## **ADDENDUM NO. 3**

**TO  
BID PROPOSAL  
AND SPECIFICATIONS  
FOR  
Wilbur Avenue Overhead Widening  
P.W. 259-B**

**ISSUED: September 27, 2012**

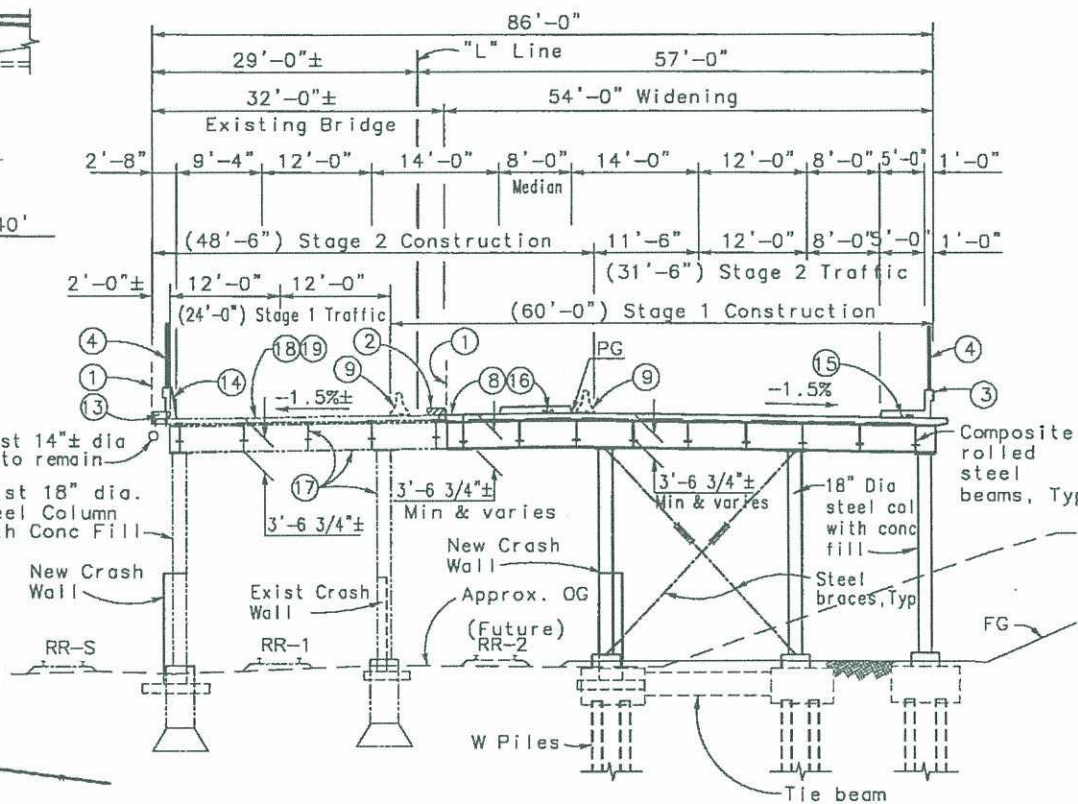
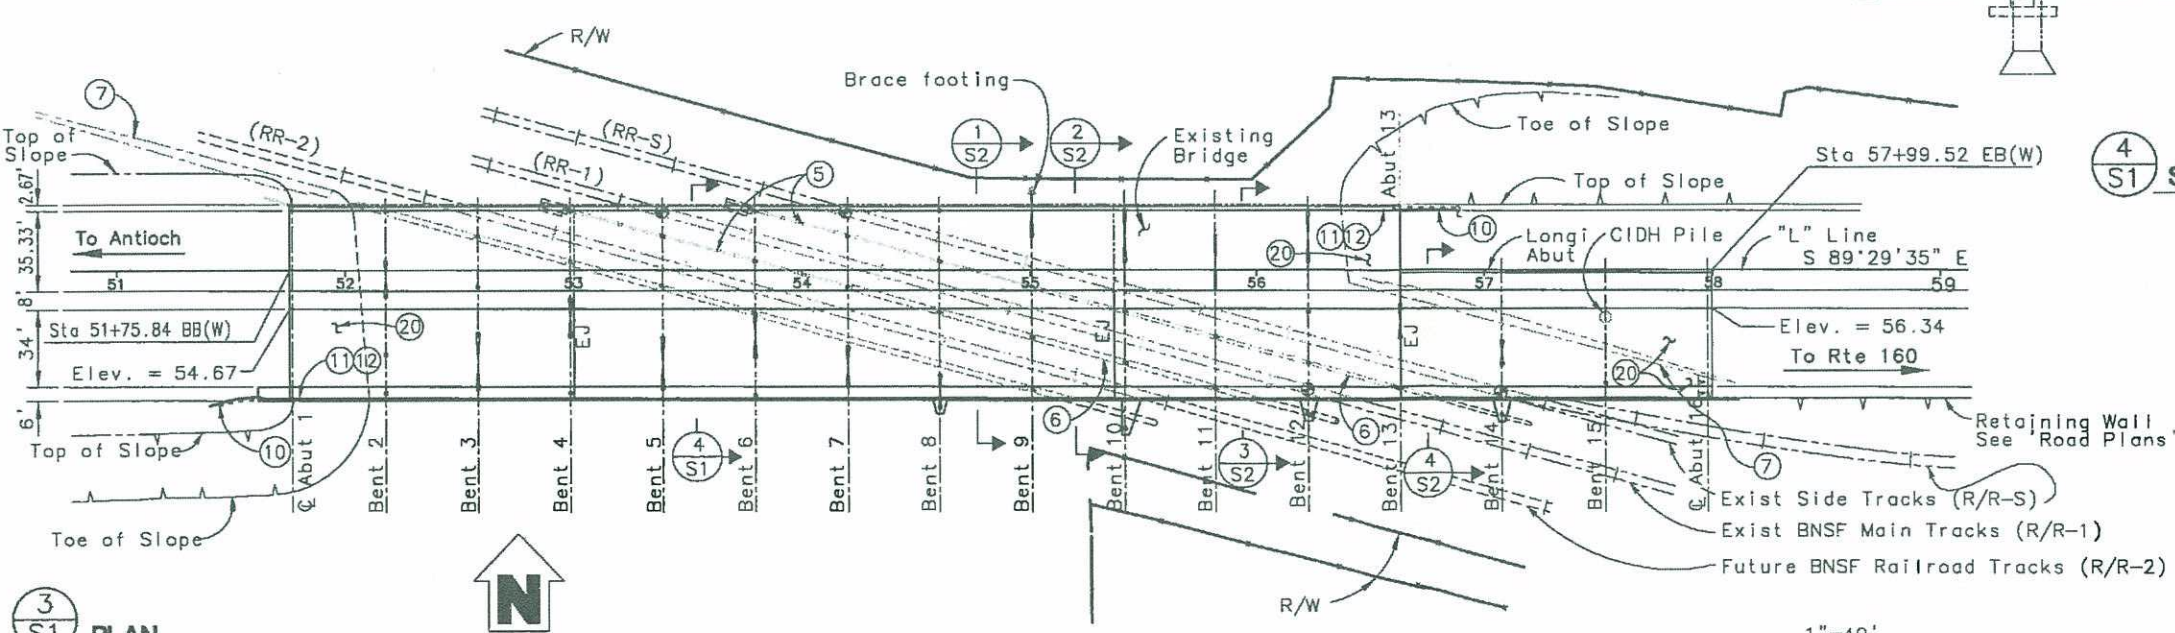
Item 17 in the legend has been updated to read "Clean and paint existing structural steel where new steel construction connects and/or disconnects the existing steel construction."
